Work Order ID 80895

Item Name: 205 Skidtube bent detail

DRAWING NO. D2580	TITLE 205 SKIDTUBE ASSEMBLY	REV. E	DART AEROSPACE LTD ENGINEERING ORDER	D.E.O. NO. D2580-E-1	SHEET NO. SHEET 1 OF 1	SCALE NTS
DRAWN <i>UP</i>	CHECKED <i>ASS</i>	MFG. APPR. <i>ER</i>	APPROVED <i>#</i>	DE APPR. <i>#</i>		
DATE 11.12.13	DATE 11.12.13	DATE 11.12.13	DATE 11.12.13	DATE 11.12.13

CHANGE ALL C'BORED WELDED CROSSBOLT SPACERS TO SWAGED SPACERS

SECTION B-B
SCALE 5X

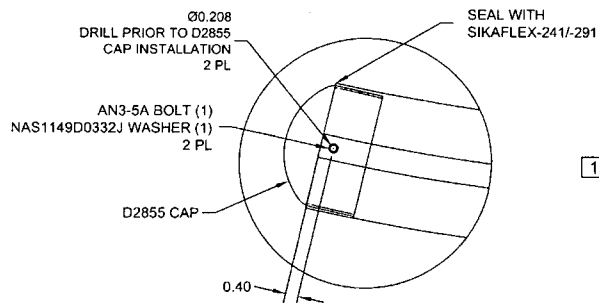
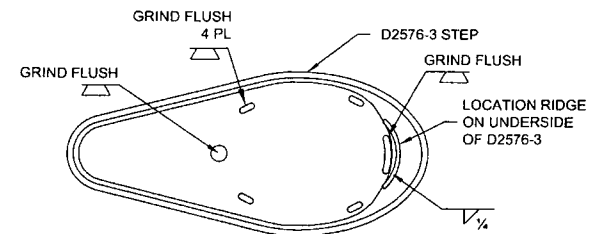
AFTER DRILLING AND BENDING ASSEMBLY
PERFORM THE FOLLOWING FOR Ø0.508 HOLES ONLY:
1. CHAMFER HOLE 0.050 X 45°
2. INSERT D2579 SPACER (20 PLACES)
3. WELD INTO PLACE AND GRIND FLUSH
4. C'BORE D2579 SPACER TO Ø0.437 X 1.00 DEEP

1. INSERT D4202-1 SPACER, 20 PL (-041) OR 20 PL (-045) OR 25 PL (-047)
2. SWAGE TO Ø0.437 X 1.00 DEEP PER QSI 002
3. TRIM / GRIND FLUSH PER QSI 002

SECTION I-I D5-7
SCALE 5X

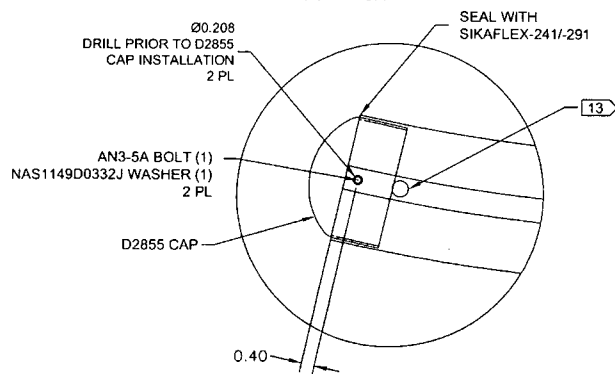
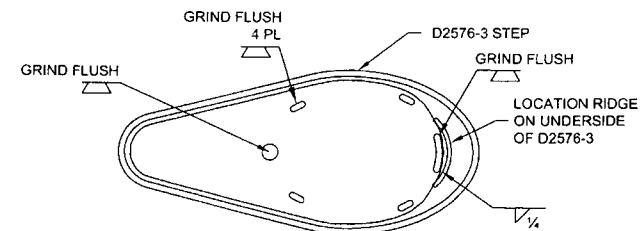
AFTER DRILLING AND BENDING ASSEMBLY
PERFORM THE FOLLOWING FOR Ø0.508 HOLES ONLY:

1. CHAMFER HOLE 0.050 X 45°
2. INSERT D2579 SPACER (25 PLACES)
3. WELD INTO PLACE AND GRIND FLUSH
4. C'BORE D2579 SPACER TO Ø0.437 X 1.00 DEEP

SECTION B-B, F-F, I-I
NOT TO SCALE

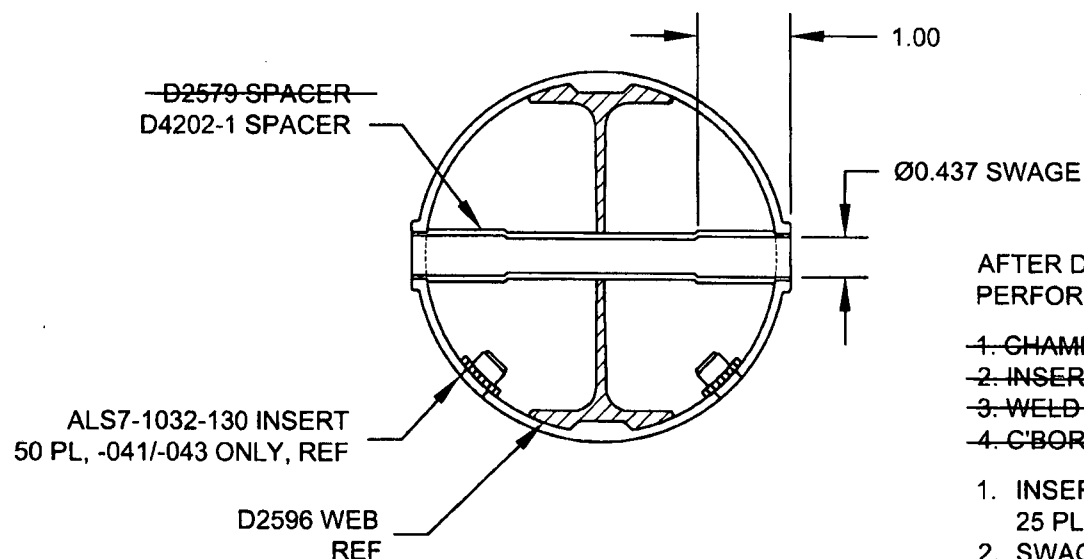
SECTION B-B, SECTION F-F, & SECTION I-I ARE AMENDED AS FOLLOWS
FOR ALL HOLES THAT WERE ORIGINALLY C'BORED:

AFTER DRILLING AND BENDING ASSEMBLY
PERFORM THE FOLLOWING FOR Ø0.508 HOLES ONLY:

1. CHAMFER HOLE 0.050 X 45°
2. INSERT D2579 SPACER (20 PLACES)
3. WELD INTO PLACE AND GRIND FLUSH
4. C'BORE D2579 SPACER TO Ø0.437 X 1.00 DEEP

WELD 4X D2579 SPACERS PER DWG
IN LOCATIONS MARKED "NO C'BORE".
REF SHEET 4 OF DWG.
